NEW IDENTIFICATION LABELS FOR COMPRESSORS

■ ■ IDENTIFICATION LABEL ■ ■

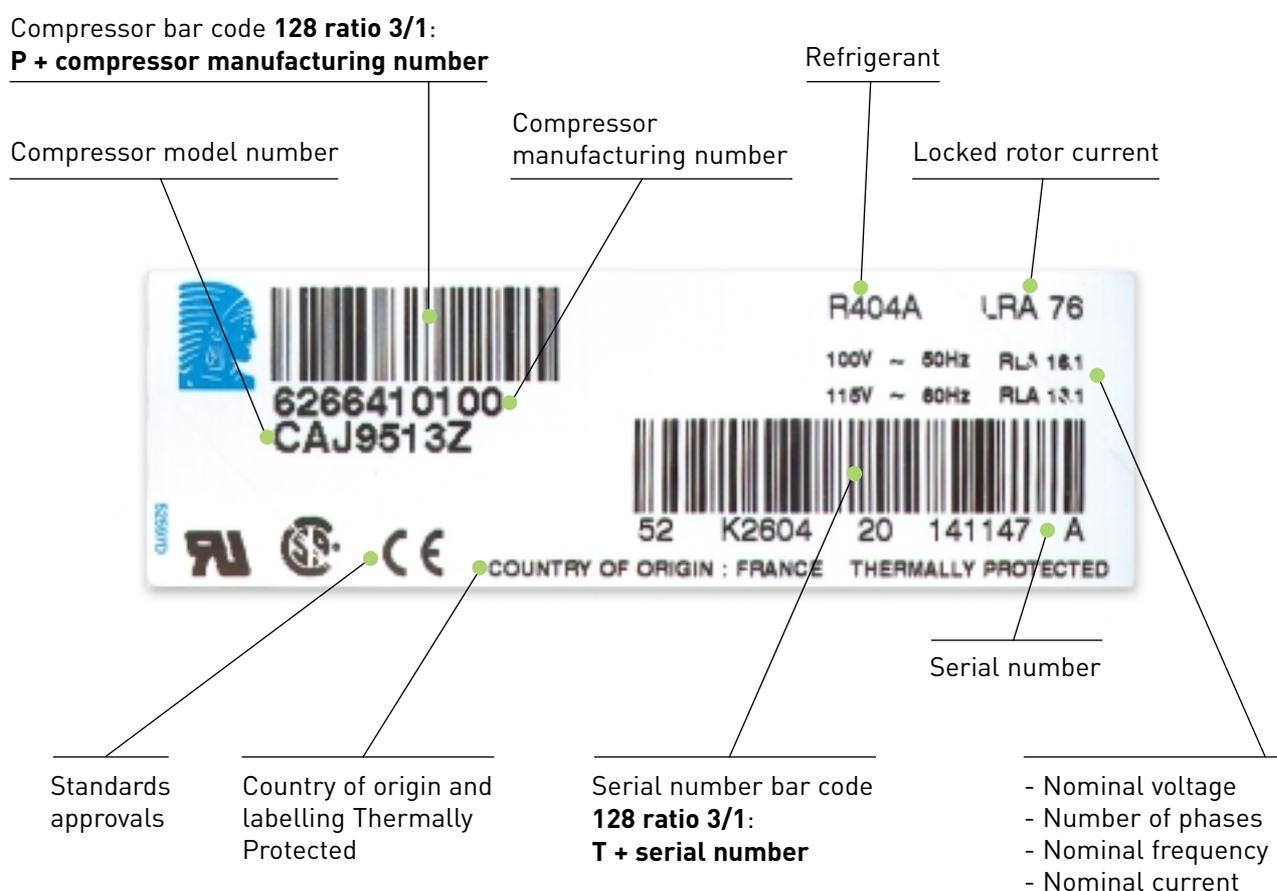
The serial number used for traceability has been changed. The description on our old labels consisted of the date of manufacture, time of manufacture and compressor manufacturing number. On our new labels, the serial number will include:

- The country of origin (e.g. **52** for Tecumseh Europe),
- the date of manufacture, a letter indicates the month, the next two digits indicate the day and the final two digits the year (e.g. **K2604** for 26 November 2004),
- a manufacturing line and team number (e.g. **20**),
- a production code indicating the hour, minute and second of manufacture (**141147** indicates 14 hours, 11 minutes and 47 seconds),
- the batch code indicated by a letter (e.g. **A**).

The serial number, e.g. **52 K2604 20 141147 A**, will also feature on the compressor packaging.

■ ■ INFLAMMABLE REFRIGERANT ■ ■

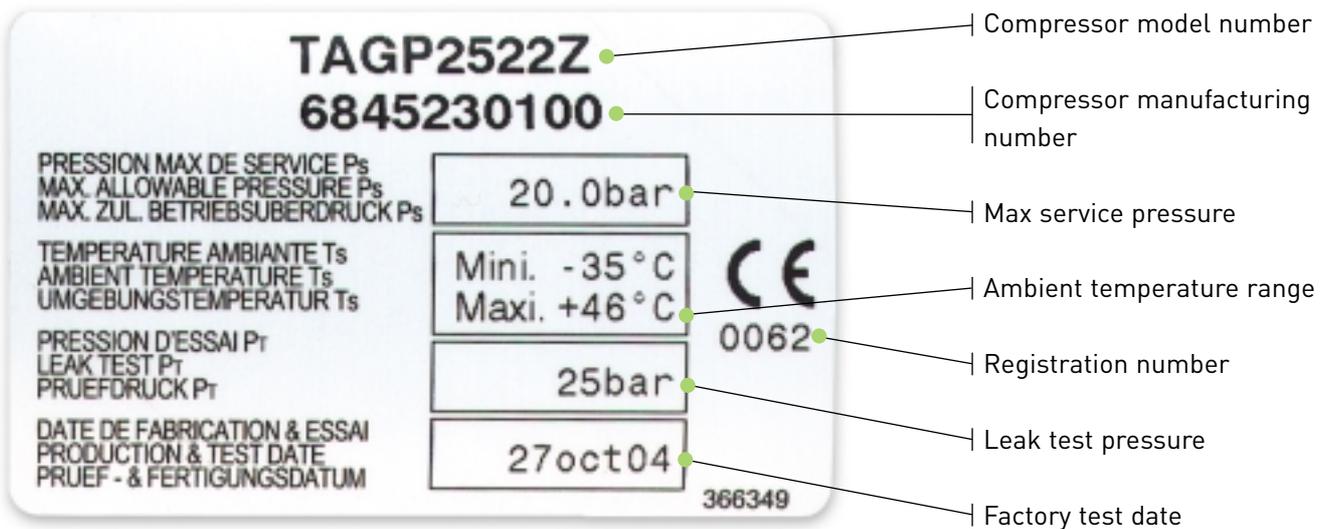
Compressors using hydrocarbon refrigerants
(e.g. R-600a and R-290) will carry
the following label.
